Recall Bulletin

SUBJECT: Ignition Lock Cylinder Binding

MODELS: 2011-2012 Cadillac Escalade, Escalade ESV, Escalade EXT
2011-2012 Chevrolet Avalanche, Silverado, Suburban, Tahoe
2011-2012 GMC Sierra, Yukon, Yukon XL

4064725

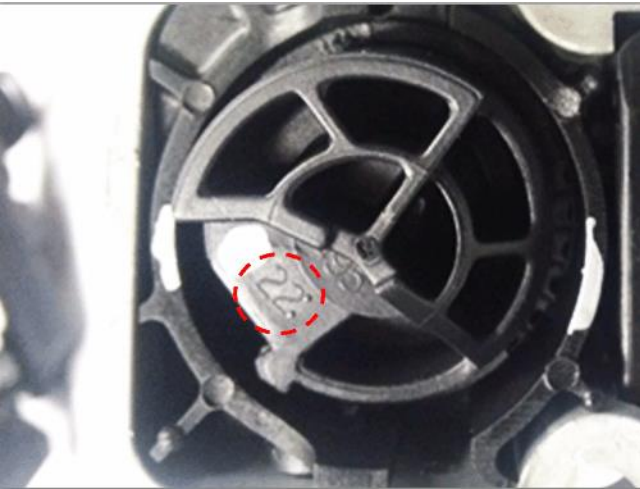
2. Inspect the inboard side of the housing for the mold cavity number, at the location shown circled in the graphic above:

- If the cavity number reads "22", the ignition lock cylinder case MAY contain the failure issue and you should move directly to the Service Procedure below.
- If the cavity number reads anything other than "22", the case can be reinstalled and no further action is required. For reinstallation, refer to Ignition Lock Cylinder Case Replacement in SI.
